C/025/0005
Received 12/31/14
Task ID #4772

Subject: **Response to Rejection for Underground Coal Mine Amendment, Task Id. 4730, Alton Coal Development, LLC, Coal Hollow Mine, Kane County, Utah, C/025/0005**

Subject: **Response to deficiencies for Underground Coal Mine Amendment, Task Id. 4652, Alton Coal Development, LLC, Coal Hollow Mine, Kane County, Utah, C/025/0005**

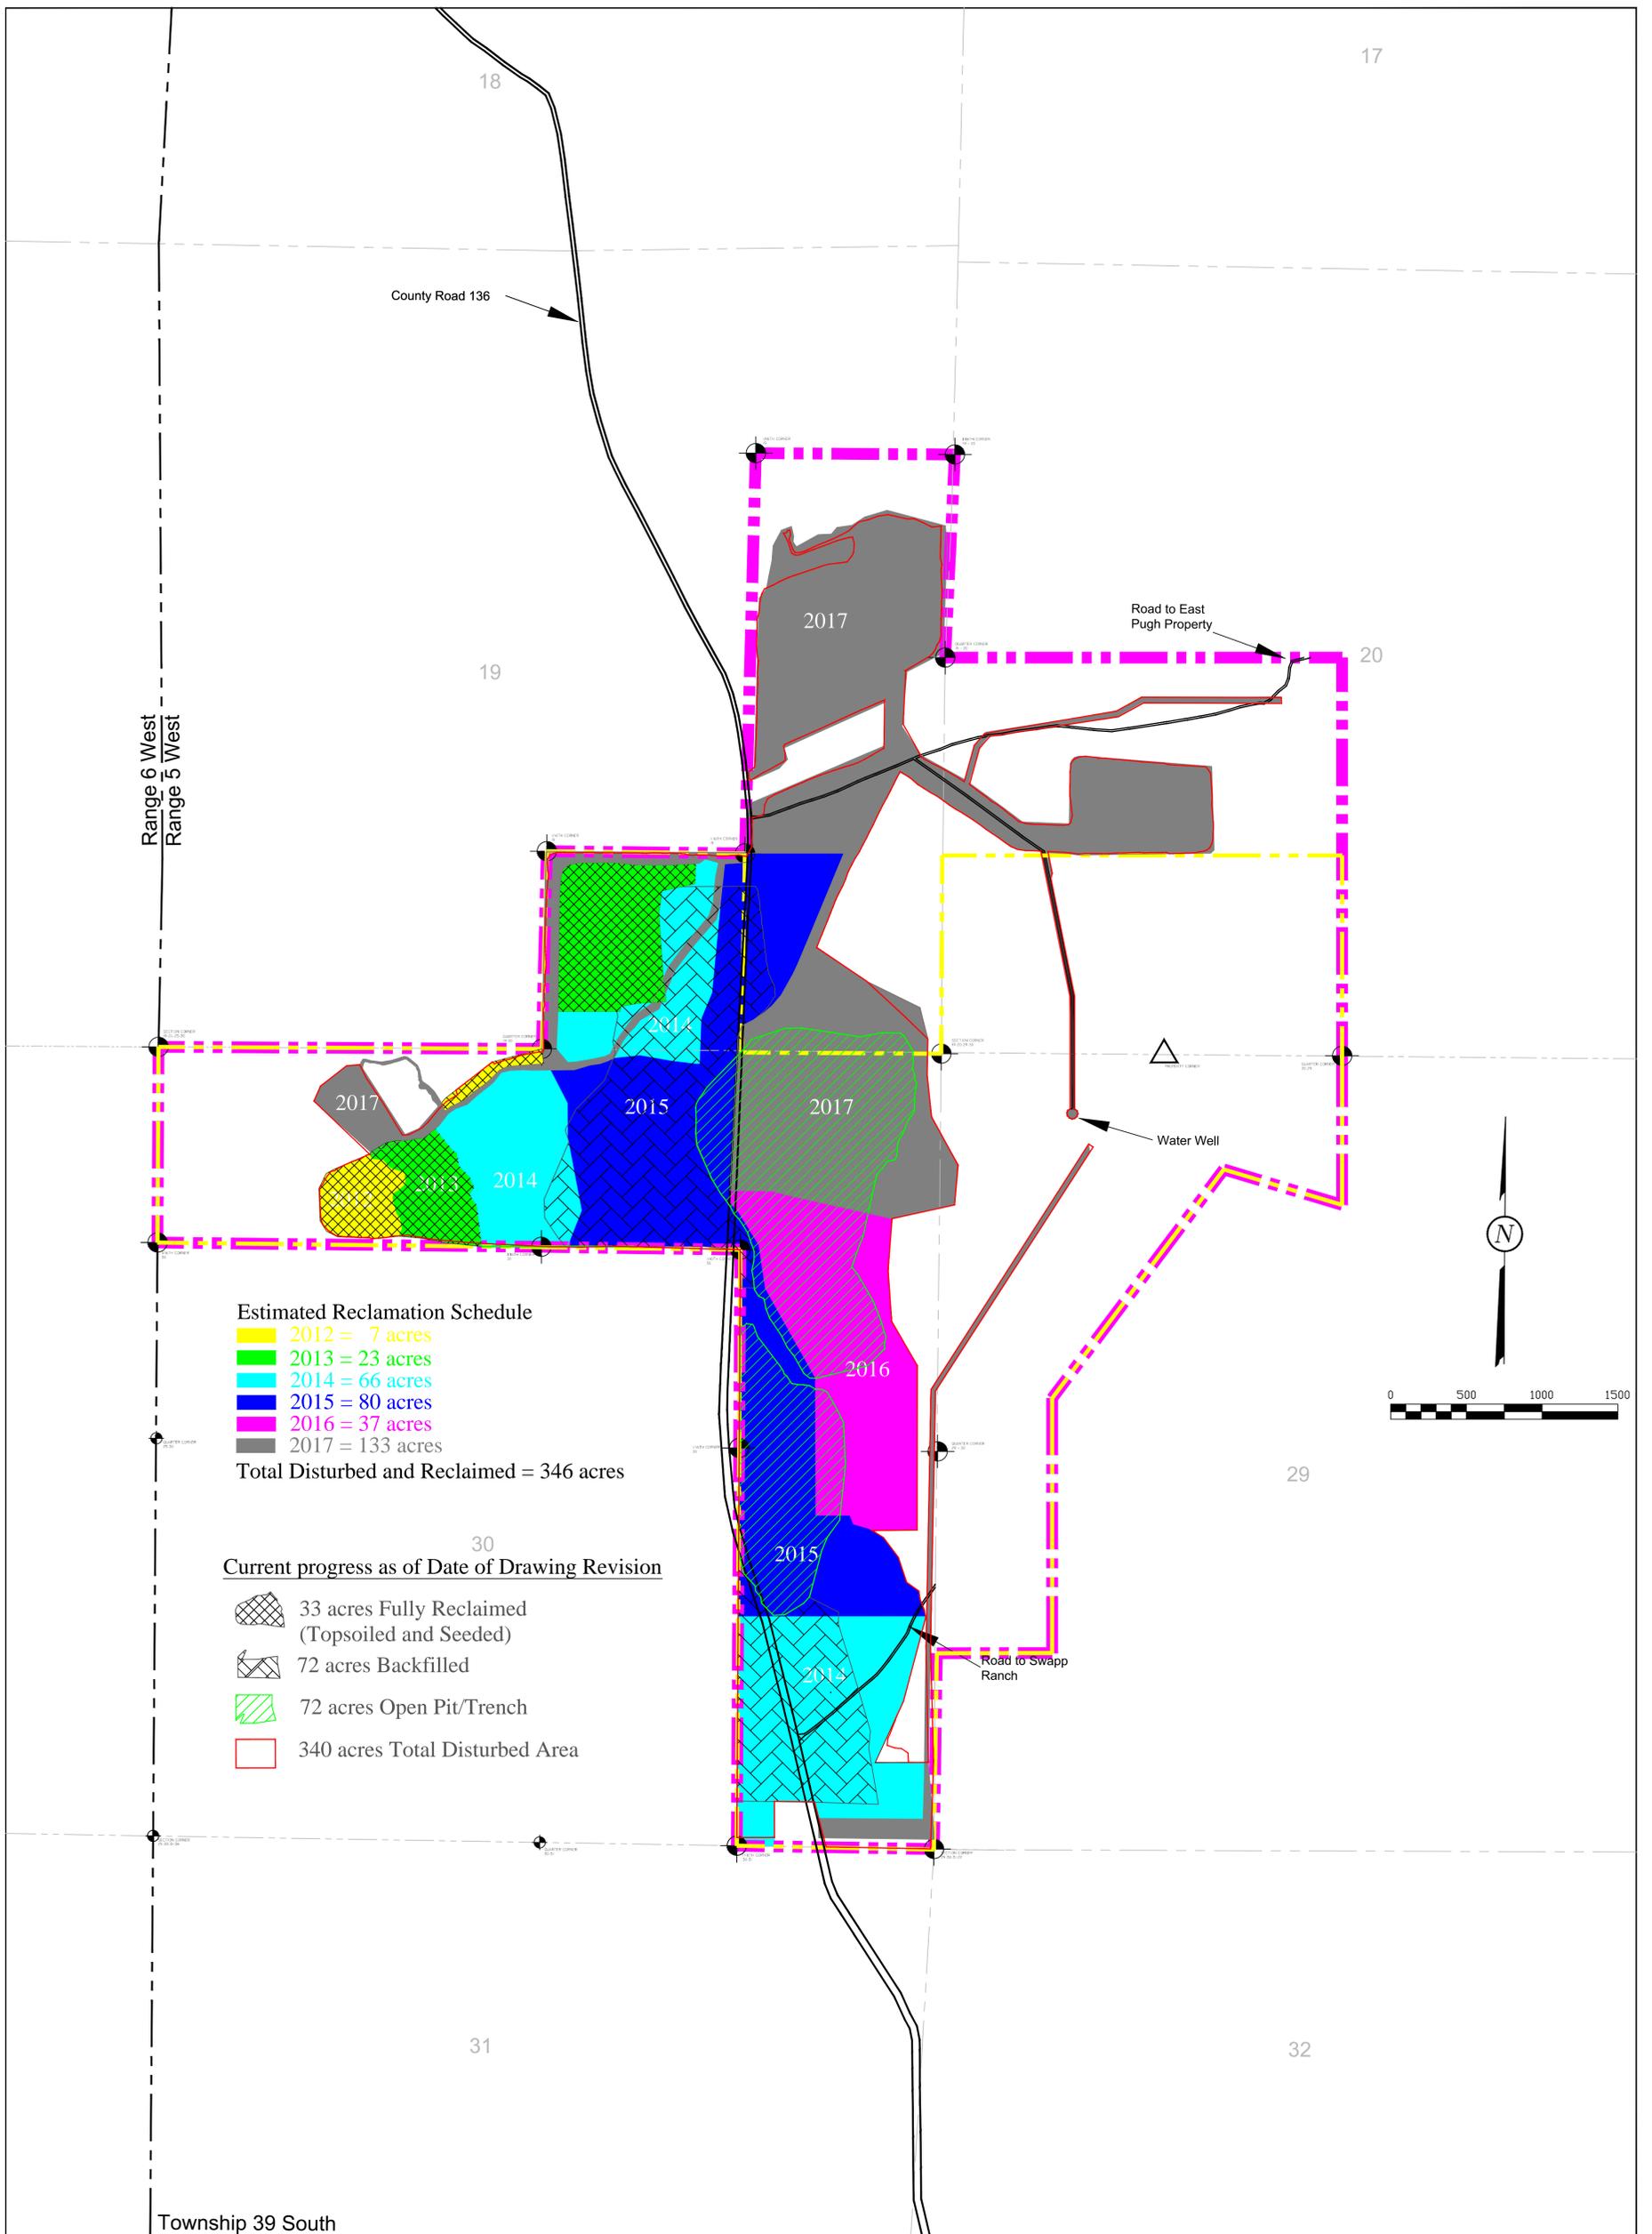
Inaccordance with the requirements of R645-3Q1-524.212, Drawing 5-38 should be re-certified for the Task ID#4652 application.

R645-301-533.700-714 The current MRP needs to be updated to reflect the changes in reclamation timing due to underground mining as it currently reflects the timing shown in Drawing 5-38.

Drawing 5-38 has been recertified.

Drawing 5-38A represents the reclamation scenario for underground mining, Drawing 5-38 has been updated to reflect reclamation timing due to underground mining.

DRAWING: 5-3B

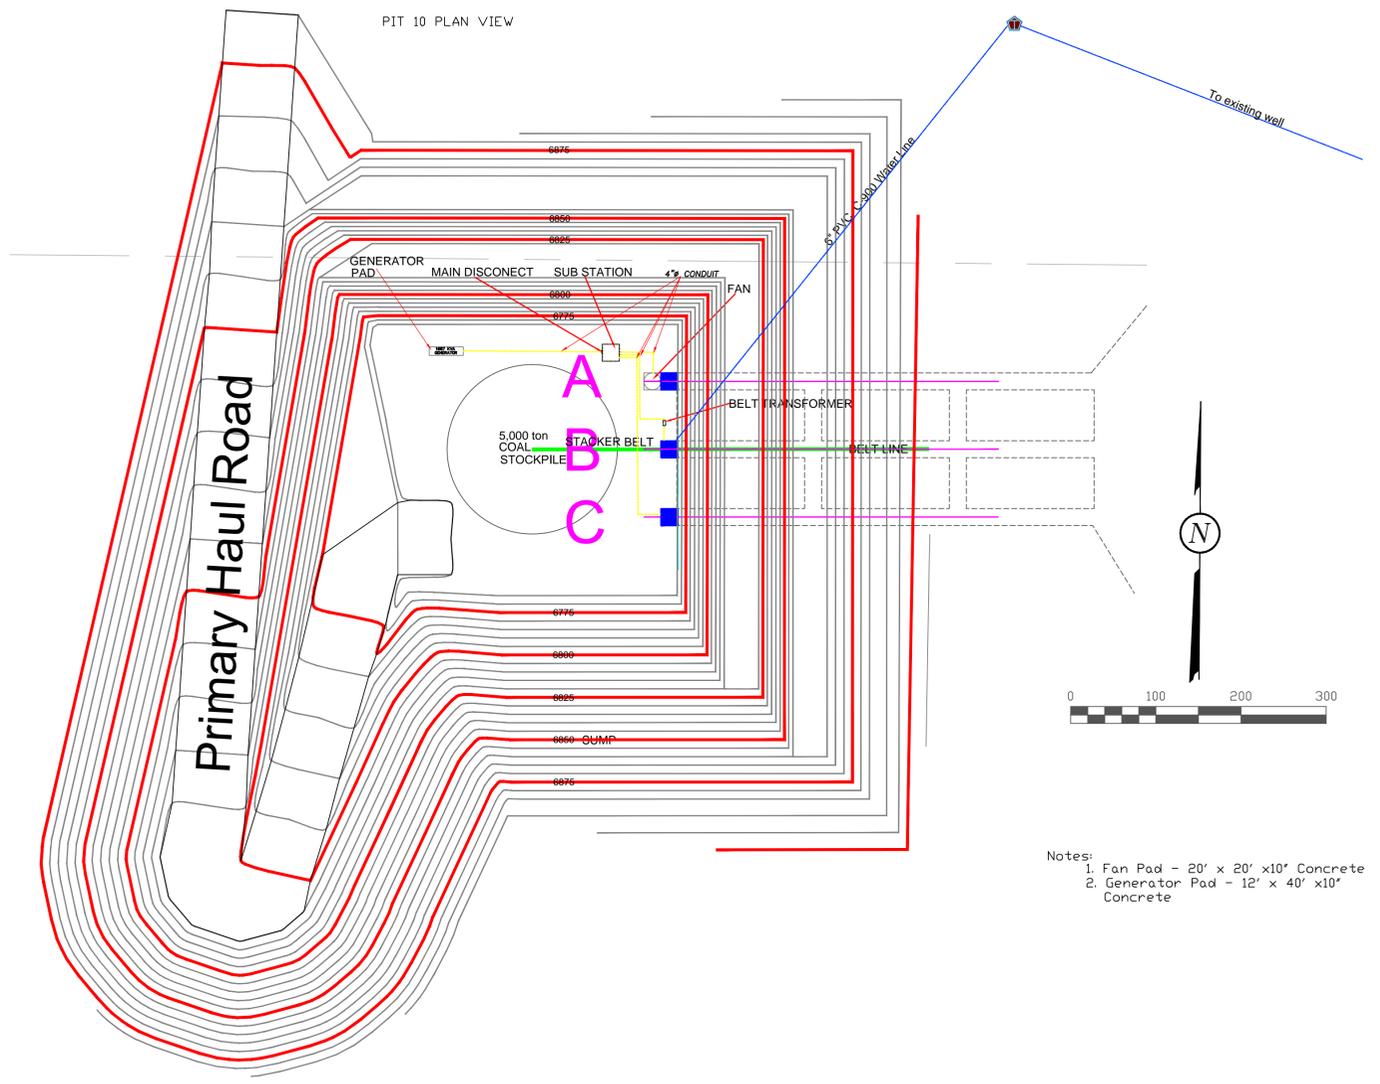
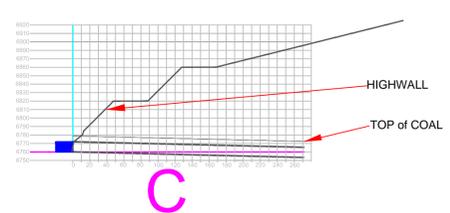
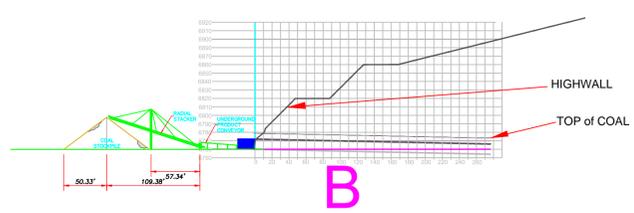
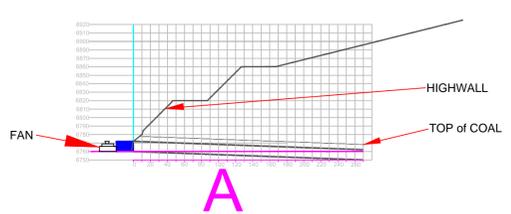
Format errors on Drawing 5-3B are erroneous or misleading include:

R645-301-512.100 and -512.110/R645-301-525.490 and -525.300
Drawing 5-3B should be updated with a current P.E. stamp in accordance with R645-301-512.100 and -512.110.

All noted format errors have been corrected on updated Drawing 5-3B.

Drawing 5-3B has been updated and certified.
